NEBRASKA ARMY NATIONAL GUARD

EAST CAMPUS READY BUILDING CONSTRUCTION

PROJECT NO. 31020079

A D D E N D U M N O . 1

2 ROOF PLAN
1/8" = 1'-0"

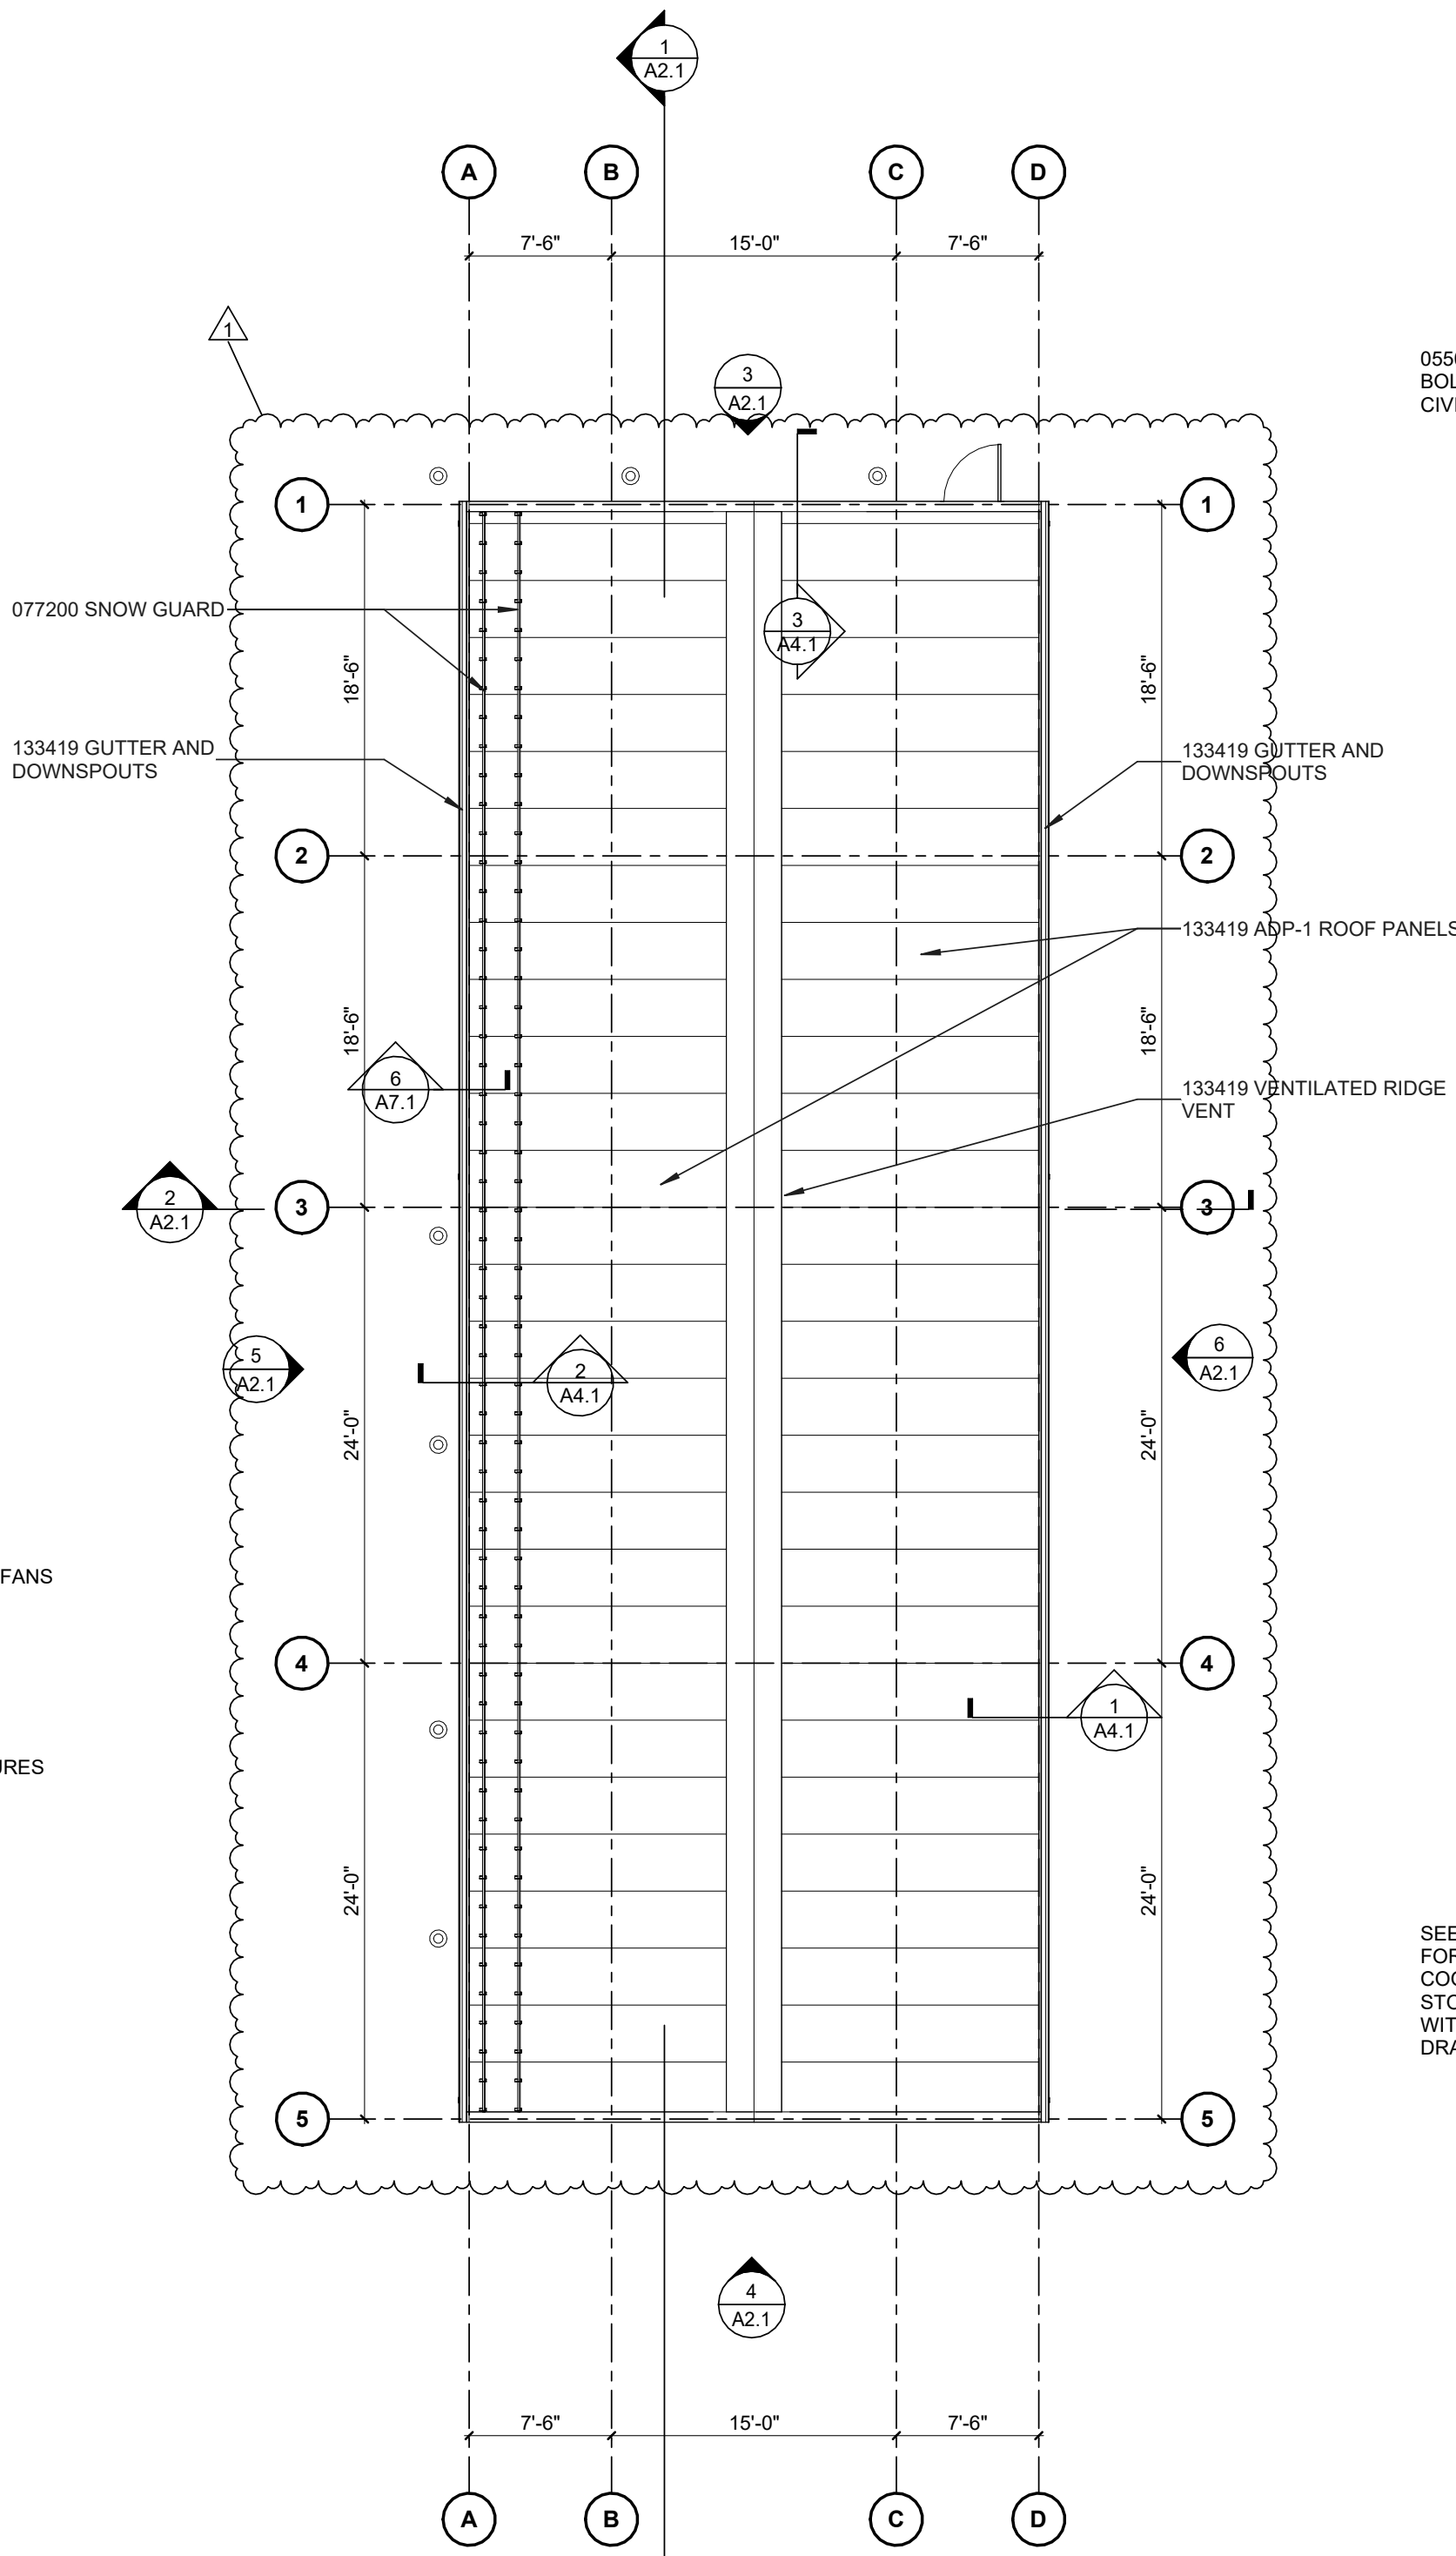
1. Sheet A1.1 – First Floor Plan, Roof Plan & Reflected Ceiling Plan.
 - a. Reference Detail 2 Roof Plan.
 - i. Add snow guards to west edge of roof as indicated.
2. Sheet E0.1 – Electrical Site Plan
 - a. New Sheet added to provide clarification on where Panel A will be fed from.
